APPLICATION NO.	FILING DATE	FIRST NAMED INVENTOR	ATTORNEY DOCKET NO.	CONFIRMATION NO.
10/824,223	04/14/2004	Wen-Yen Lin	251702-1360	6290

Office Action Summary

DETAILED ACTION

Fig 1

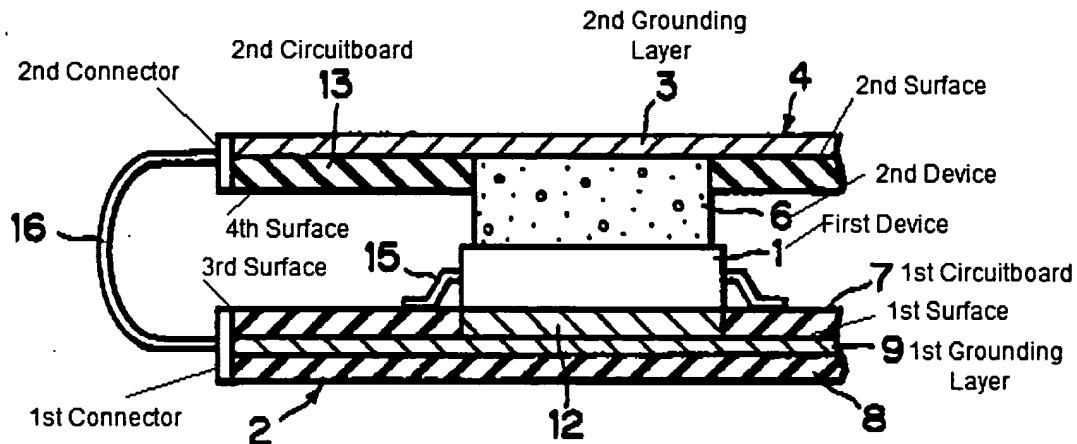
With respect to claim 1, Nakamori teaches a function module comprising: a first circuit board (7) including a first surface (See present office action Fig 1 below) with a first ground layer (9) formed thereon; a second circuit board (13) coupled to the first circuit board (Via 16), including a second surface (See present office action Fig 1 below) facing the first surface, wherein a second ground layer (3) is formed on the second surface. Nakamori fails to teach a plate-type heat dissipation device, disposed between the first circuit board and the second circuit board, abutting the first ground layer and the second ground layer respectively.

With respect to claims 2 and 17, Nakamori further teaches that the first circuit board further includes a third surface (See present office action Fig 1 above), opposite the first surface, with a first device (1) located thereon.

With respect to claims 3 and 18, Nakamori further teaches that the second circuit board (13) further includes a fourth surface (See present office action Fig 1 above) opposite to the second surface, with a second device (6) located thereon.

With respect to claims 7 and 22, Nakamori further teaches that the first circuit board (7) includes a first connector (See present office action Fig 1 above), the second circuit board (13) includes a second connector (See present office action Fig 1 above) corresponding to the first connector, and the first circuit board and the second circuit board communicate with each other by the respective connectors.

With respect to claims 8 and 23, Nakamori further teaches that the first connector is located on the first surface, and the second connector is located on the second surface (As illustrated in Fig 1 above the connectors are located on the first and second surfaces for at least the reason that they touch each surface).

With respect to claim 15, Nakamori teaches a function module comprising: a first circuit board (7) including a first surface (See present office action Fig 1 above) with a first heat conduction layer (9) formed thereon; a second circuit board (13), coupled to the first circuit board (Via 16), including a second surface (See present office action Fig 1 above) facing the first surface, on which a second heat conduction layer (3) is formed. Nakamori fails to teach a plate-type heat dissipation device, disposed between the first circuit board and the second circuit board, abutting the first heat conduction layer and the second heat conduction layer respectively.
